The Leicestershire County Council (A606 North and East Melton Mowbray Distributor Road) Compulsory Purchase Order 2020 (“CPO”)

The Leicestershire County Council (A606 North and East Melton Mowbray Distributor Road) Side Roads Order 2020 (“SRO”)

Your client: Jelson Limited (“Jelson”)

GENERAL ARRANGEMENT AND CPO OUTLINE SHEET 6 OF 21, drawing number [REDACTED]

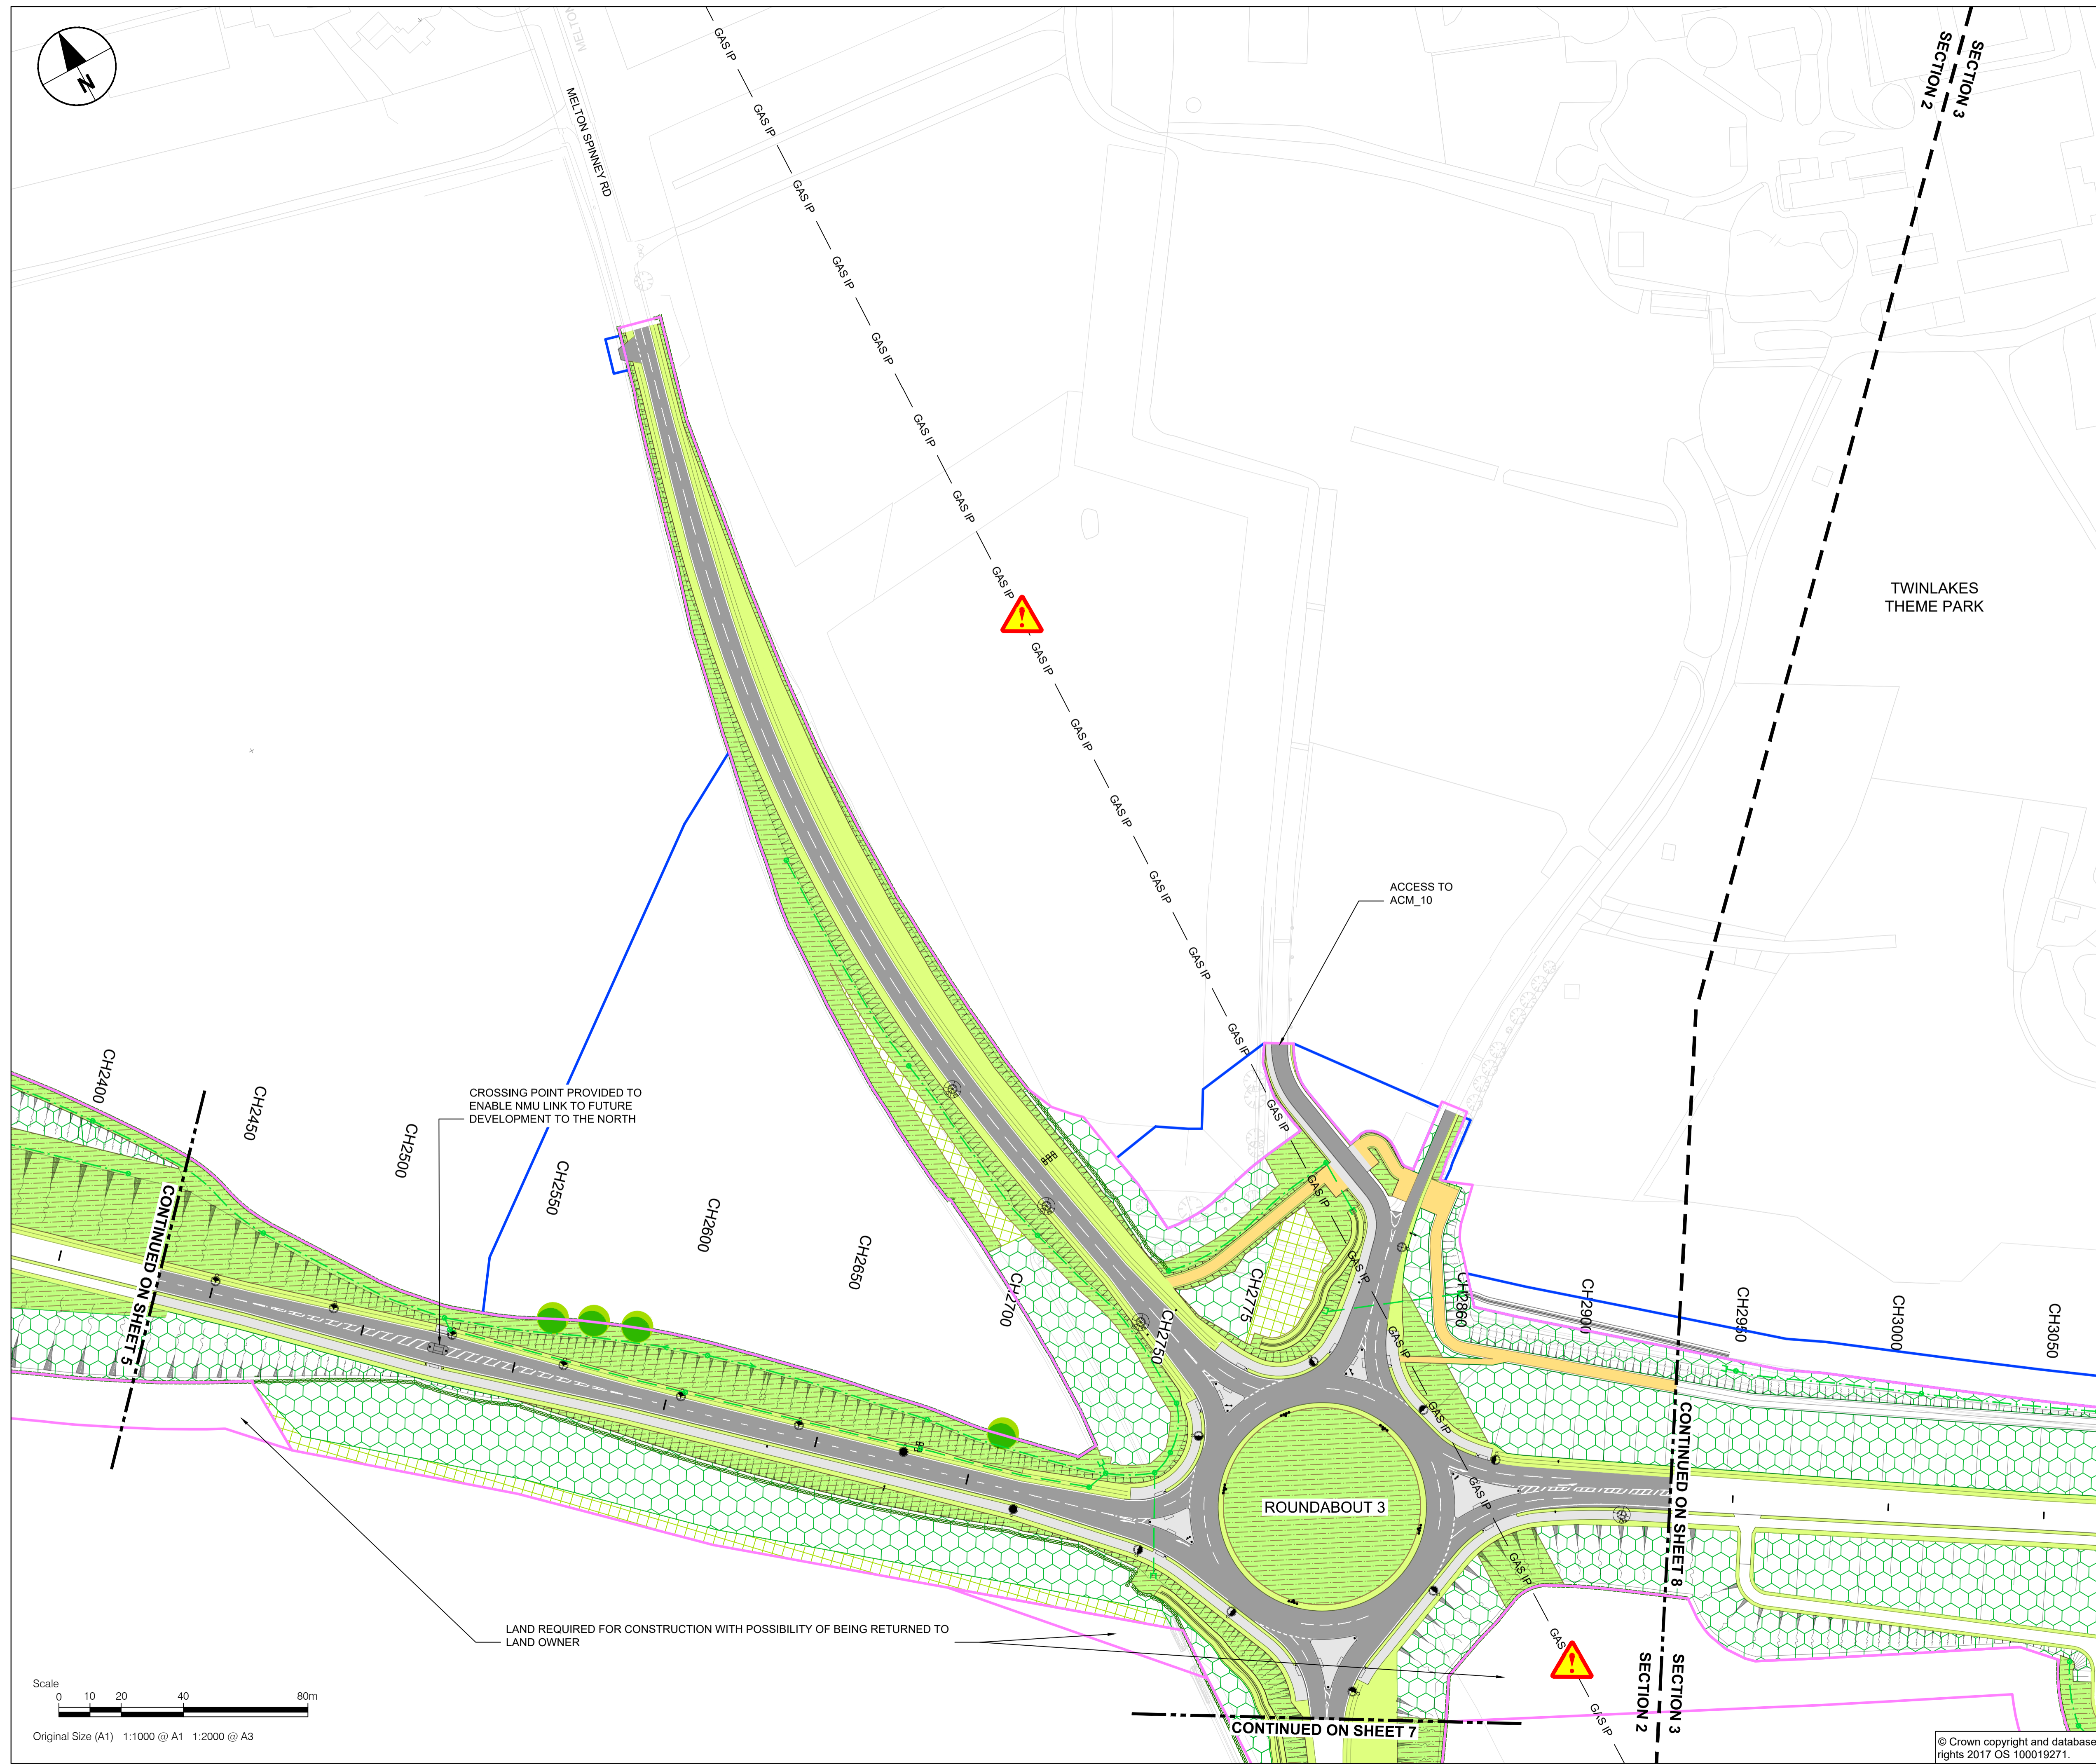
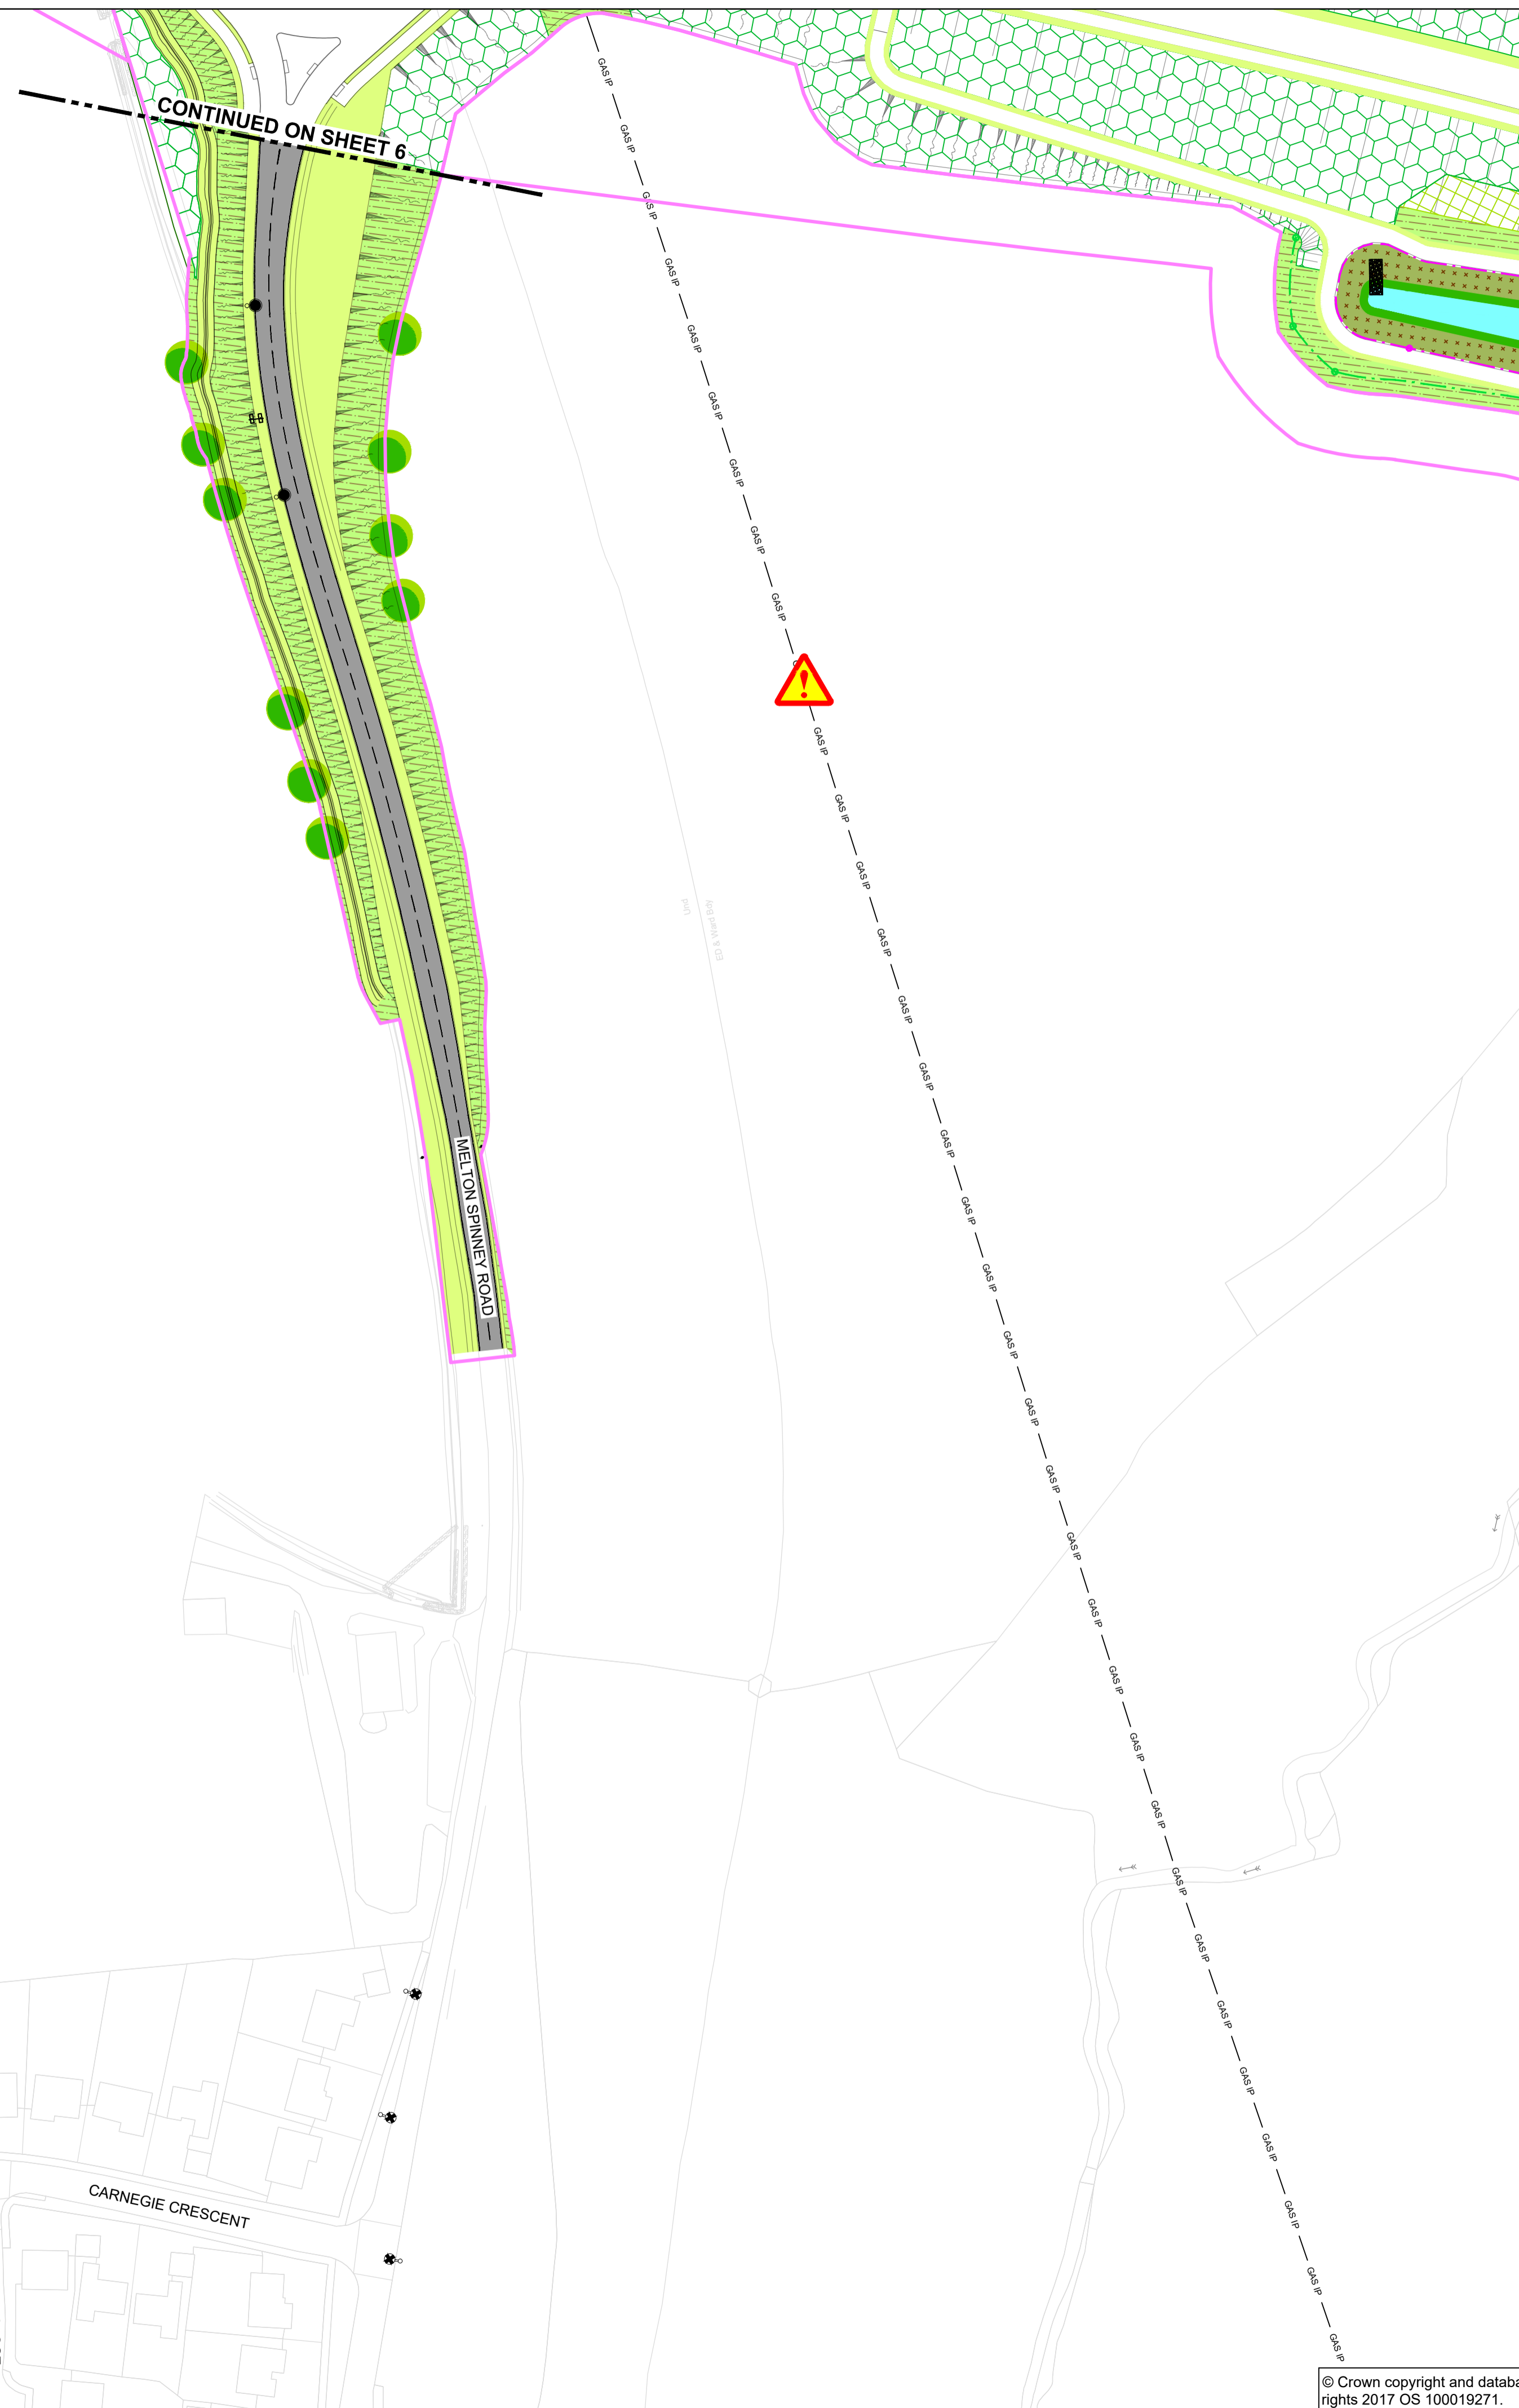
- 1.4. The Council remain committed to securing Jelson's interests in the land by agreement and are open to negotiation.
2. Your second objection is that the proposed land take is excessive; in Plots ■ and ■ appearing sufficient to deliver a dual carriageway road on a very shallow embankment.

- 2.4. Also attached to this response in ■■■■■ are plans which show the scheme General Arrangement overlaid with the CPO boundaries. It can be observed that the permanent construction is confined to Plot ■. The need for Plot ■ is a long-term operational requirement, being necessary for the construction of the road. As set out in the ■■■■■, this plot may be capable of being offered back to the owners on completion of the works, although the nature of the land may be altered.

- 2.5. Accordingly, the land take is the minimum required to deliver the Scheme.
3. Your third objection relates to the impact on retained land at Plots ■ and ■ and access to that land during and after construction.
